ADDENDUM NO. 1

PROJECT: Parking Lot Expansion and Improvements at
Goodings Grove School
Homer Community Consolidated School District 33C
Homer Glen, Illinois
Inspec Project No. 301918

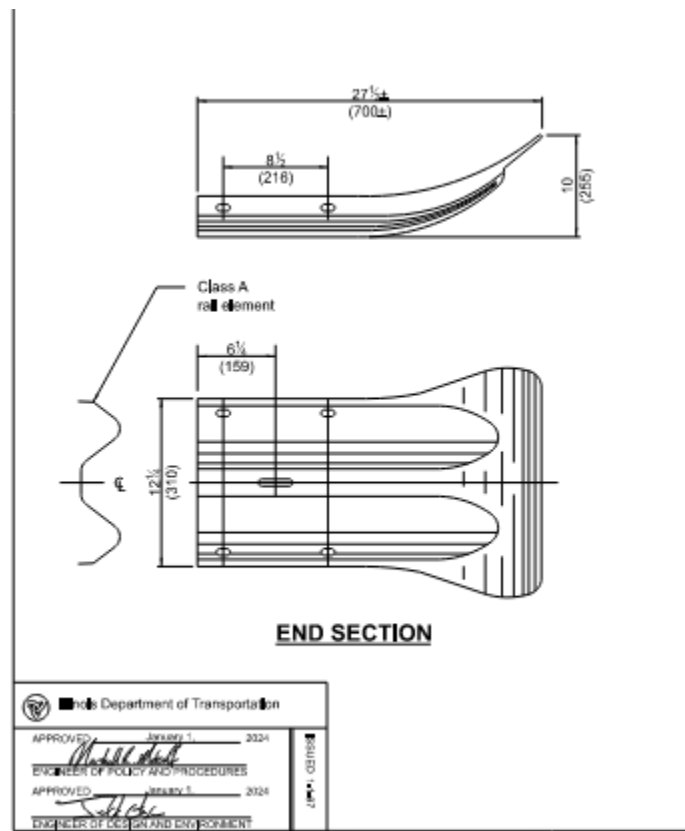
- Drawing C28 – Base Bid removal note #13, update note as follows: Contractor shall remove light pole and light fixture in addition to removing the concrete base. Owner’s electrical contractor will disconnect and remove the wires prior to construction.
- Drawing C50 – Clarification: Substitutions will not be allowed for the Contech ChamberMaxx below grade infiltration/detention system. The layout and design have been approved by authorities having jurisdiction. During the submittal process, a full shop drawing submittal will be required to verify/confirm all components.
- Detail 3/C62, add the following: At each end of steel plate beam guardrail provide IDOT end section as shown below. End sections are required at six locations since guardrail is interrupted by two light poles.
